State of California
AIR RESOURCES BOARD

Executive Order G-70-118-AB

Modification to the Certification of the Amoco Oil Company V-1 Bootless Nozzle Vapor Recovery System

WHEREAS, Amoco requested certification of a modified V-1 system. The modification consists of the installation of a non-optional Efficiency Compliance Device (ECD) on the nozzle;

Figure 2C-1

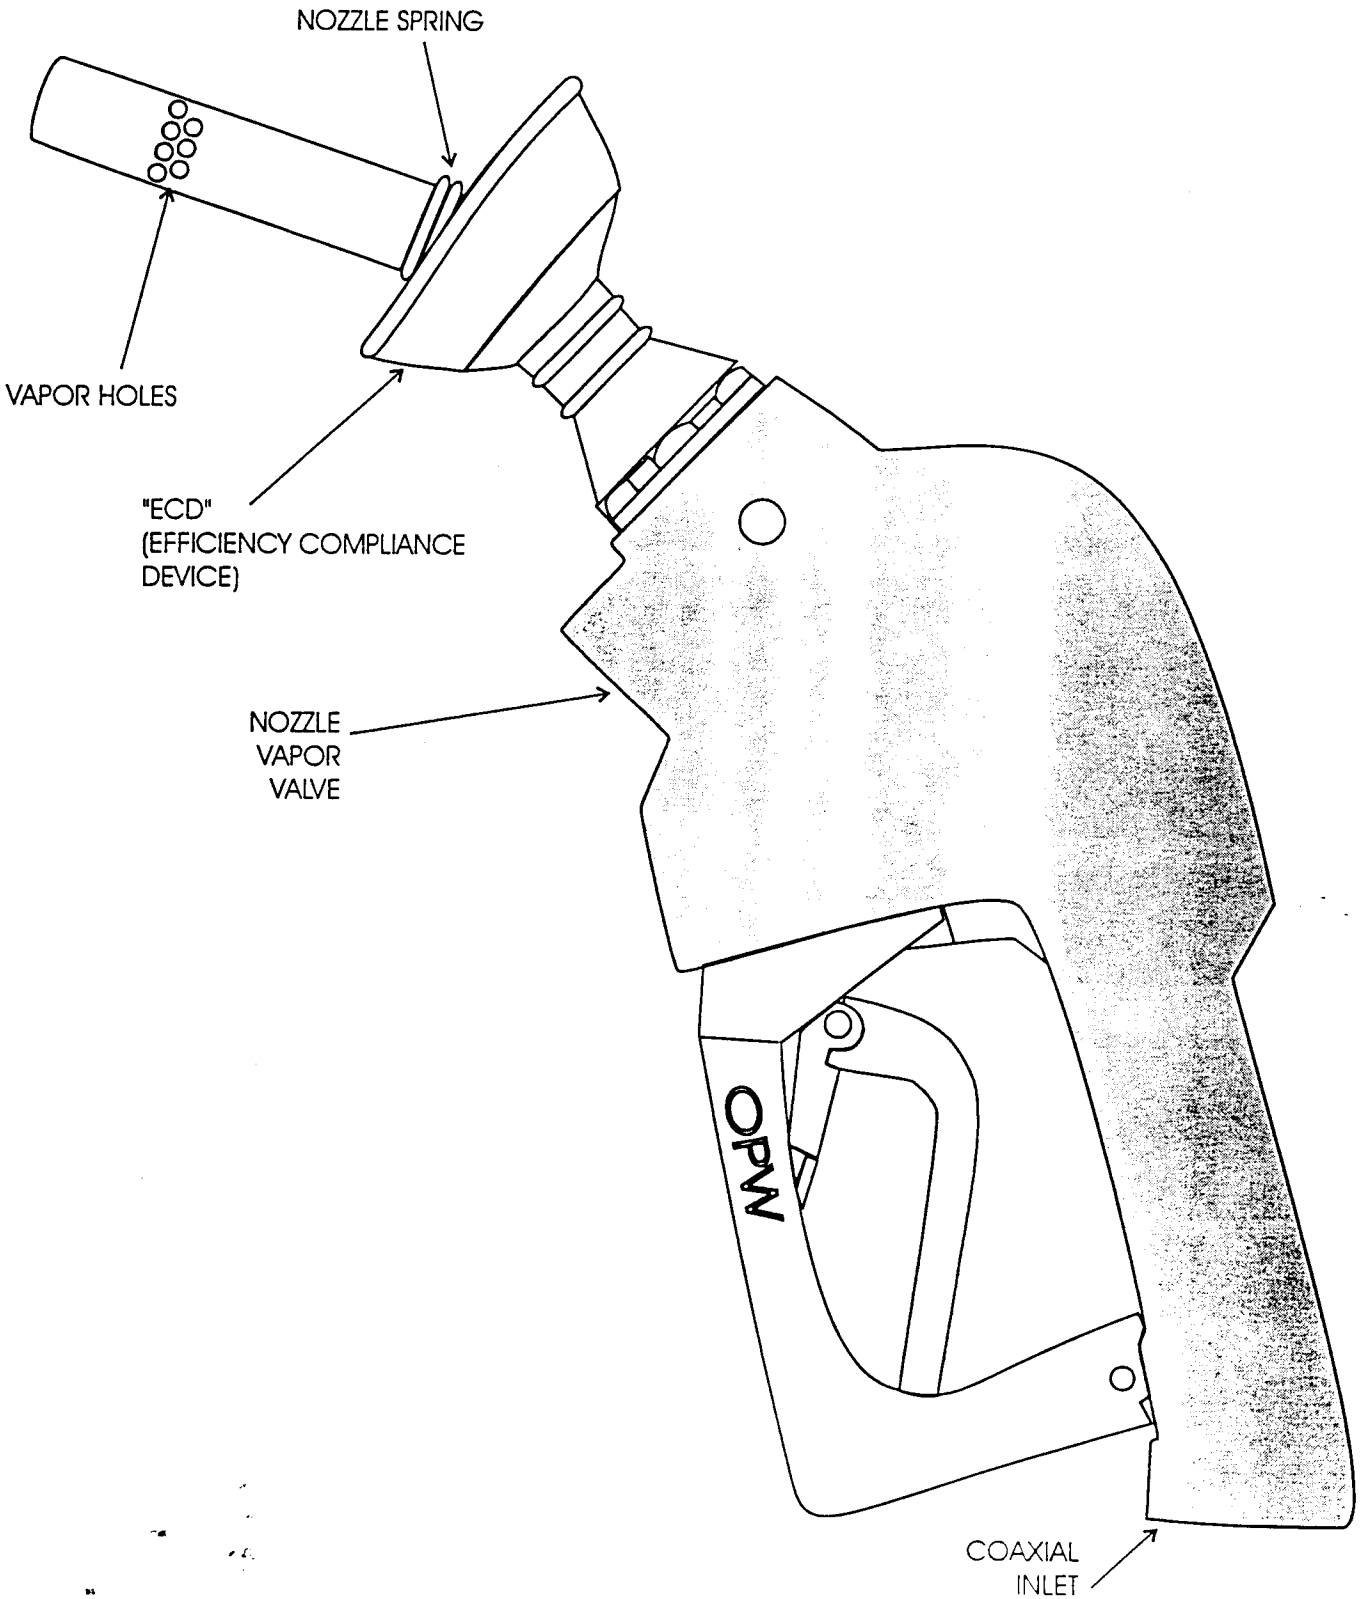
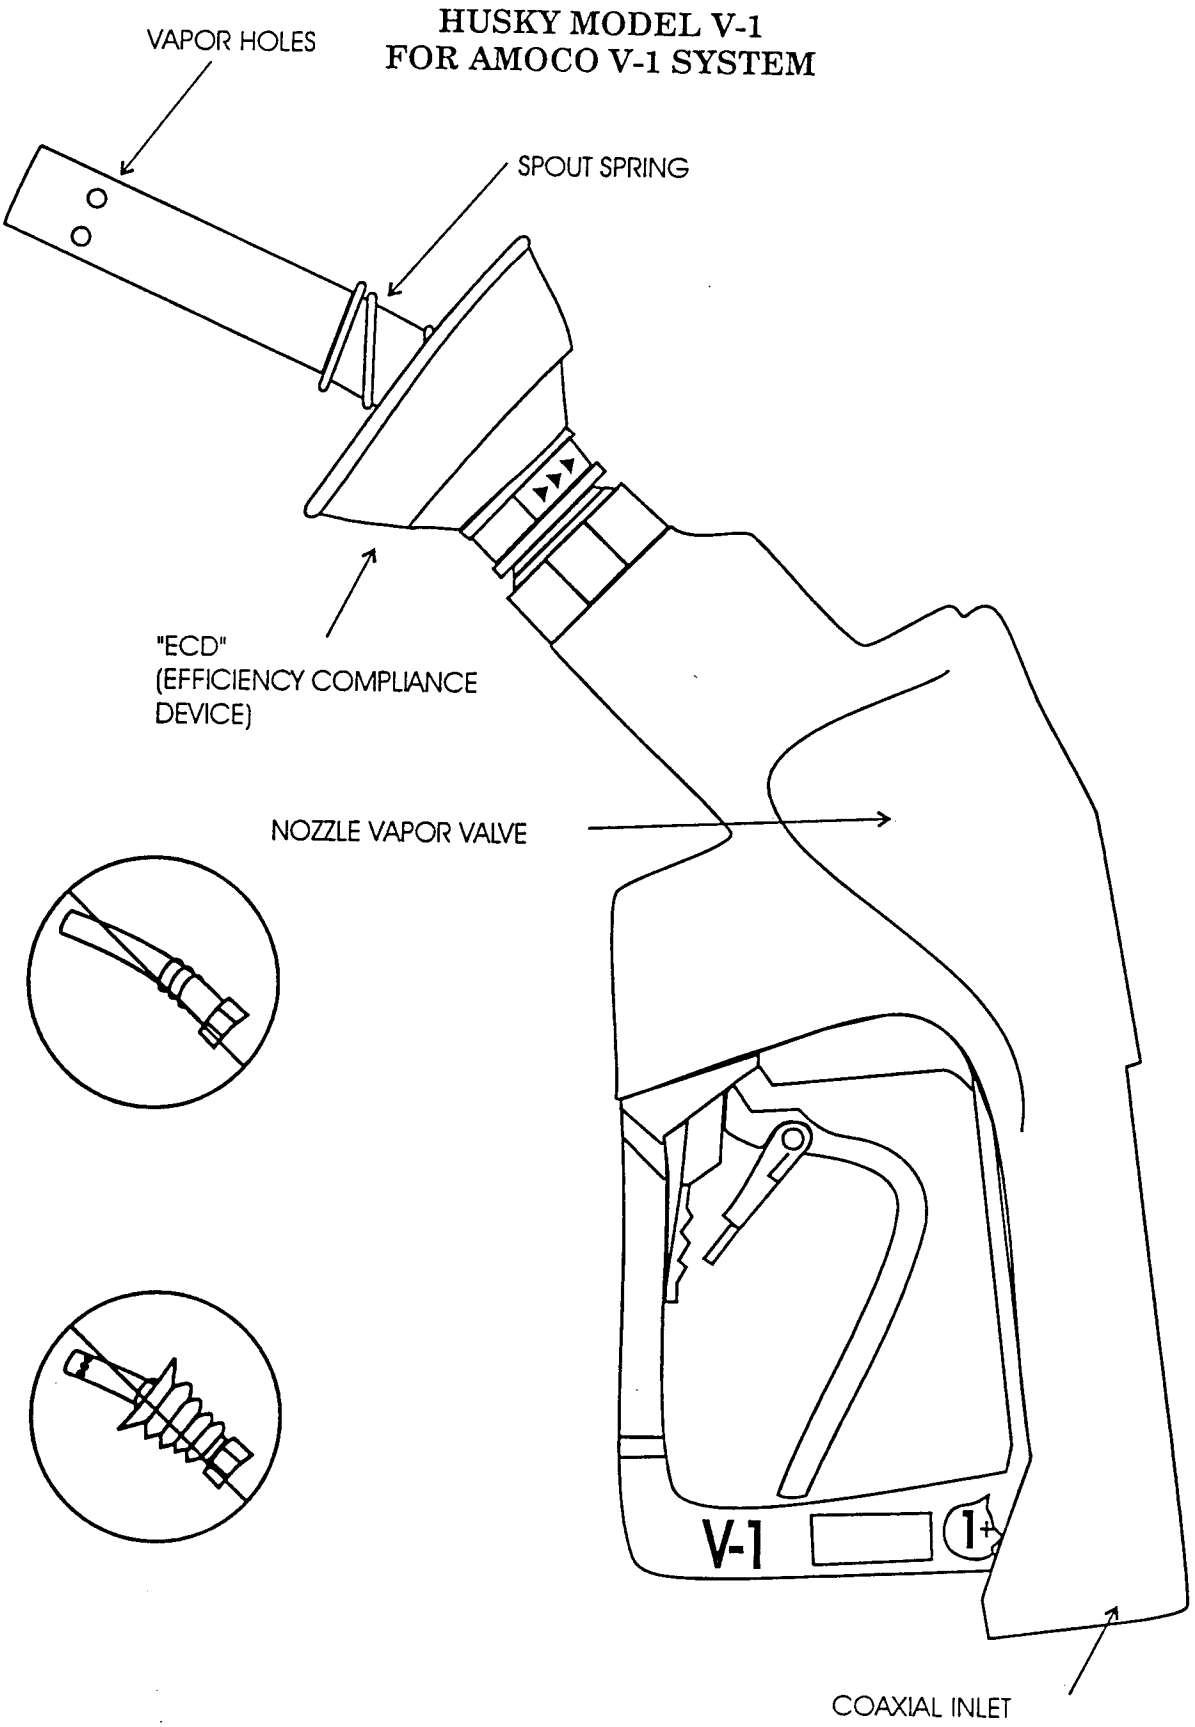
1. An efficiency compliance device (ECD) shall be installed on the Husky V-1 and OPW 11-VAA nozzles at the base of the spout as shown in Figures 2C-1 and 2C-2. Any nozzle with an ECD which is missing is deemed defective and shall be immediately removed from service. For the Husky V-1 nozzle, any ECD which is damaged such that at least one-eighth (1/8) of the diameter is missing, or has cumulative damage equivalent to at least 1/8 of the diameter missing, is defective and shall be immediately removed from service. For the OPW 11-VAA nozzle, any ECD which is damaged such that a slit from the outer to inner edge exists, or has cumulative damage equivalent to this, is defective and shall be immediately removed from service. Any nozzles which was installed without an ECD prior to the issuance of this Order shall be equipped with an ECD within 60 days of the effective date of this Order, or shall then be considered defective.
